Grosenbacher Road 16-Inch Approach and Border Main Project

Solicitation Number: CO-00220

Job No.: 18-1125

ADDENDUM 1

TREE PRESERVATION PLAN
OFF-SITE WATER EASEMENT

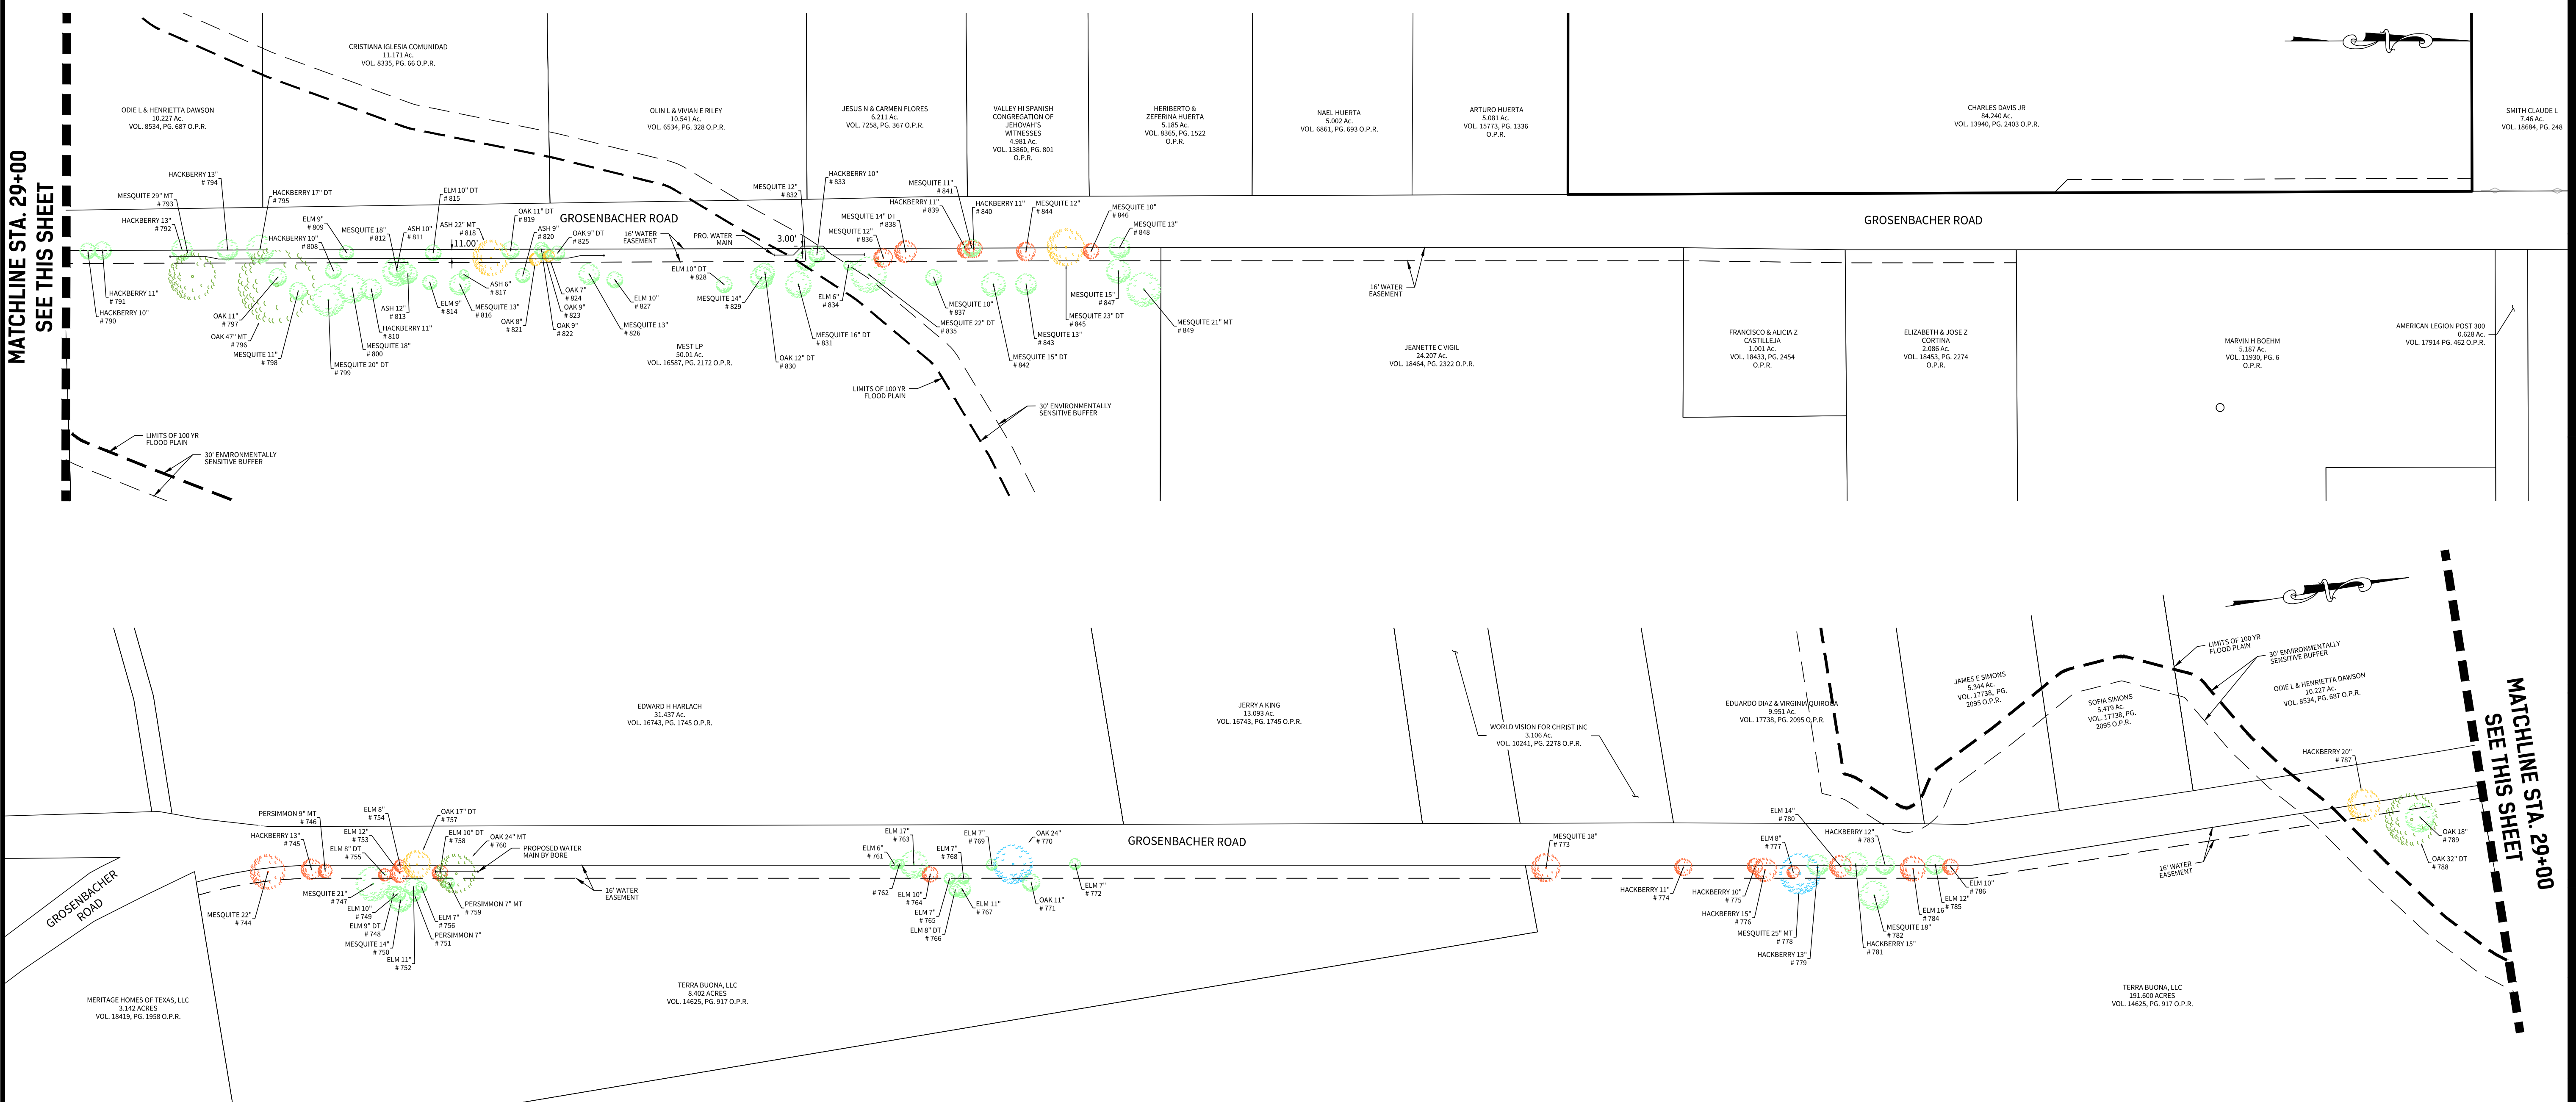
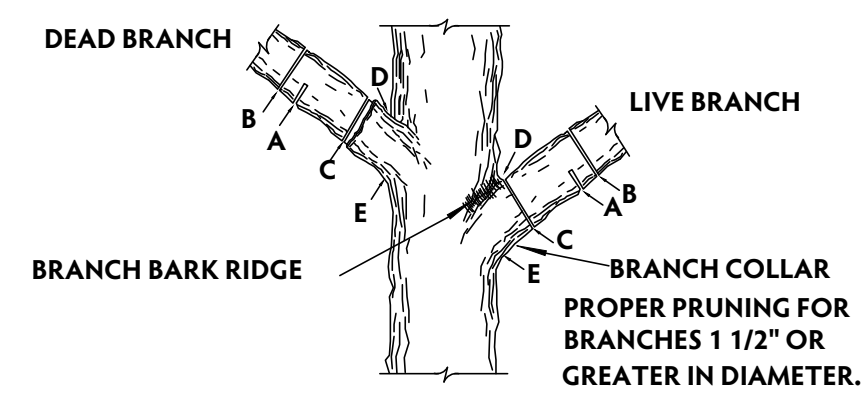
7. Question: Bid Item No. 18 shows 43 ea. tree protections. Will SAWS show with drawings how this work can be done in a 16 ft. easement with the new water line in the middle of the easement without trimming the trees and cutting roots? Does SAWS intend to use bends to go around the trees? Does SAWS intend to bore these trees?

Response: No TxDOT permit will be required.
17. **Question: Is there a tree plan drawing on the trees that need to be saved?**
Response: Tree protection plan is attached to addendum.

Response: One tree is intended to be bored (the bore located in private property). There are some locations where the intent is to trench through the outer half of the root protection zone and save the tree however there are no locations where the alignment is intended to be trenched within the inner half of the root protection zone and the tree to be saved. Bends have already been added to the alignment to compensate for trees to be saved.
